REMARKS

The claimed invention is directed to a liquid crystal display having improved brightness.

[Figure 11] PRIOR ART

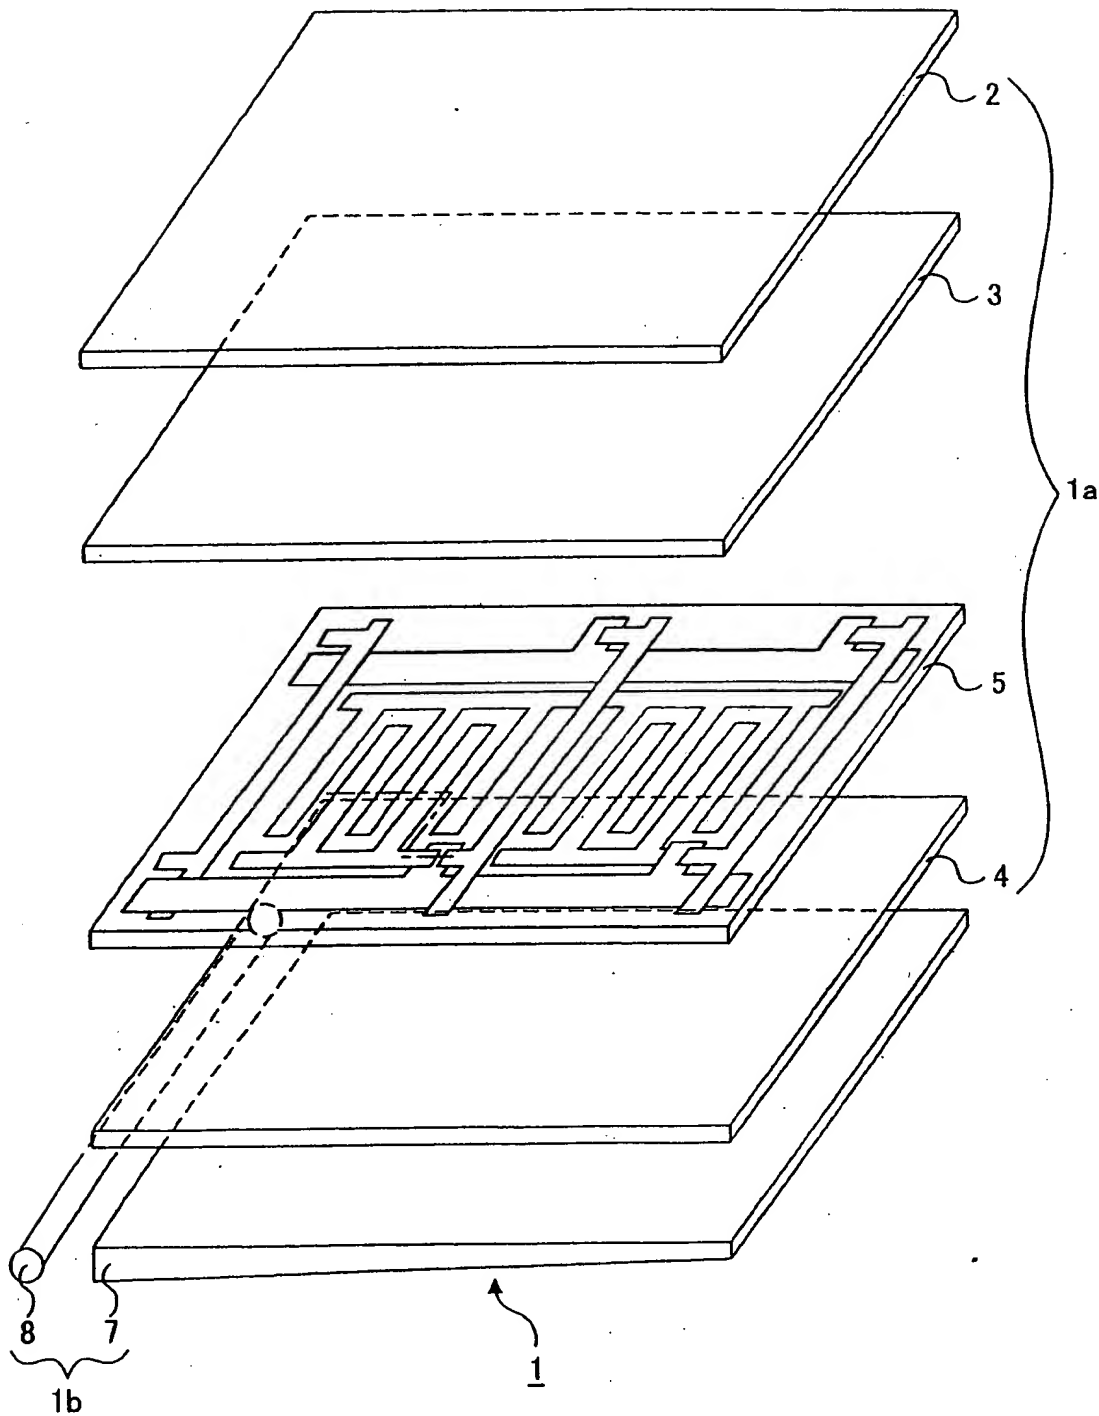
The Office Action objects to Figures 11 and 12 because they have not been designated as "prior art". Figures 11 and 12 are amended herewith to include the designation "prior art" as suggested by the Examiner. Therefore, the Examiner is requested to withdraw this objection.
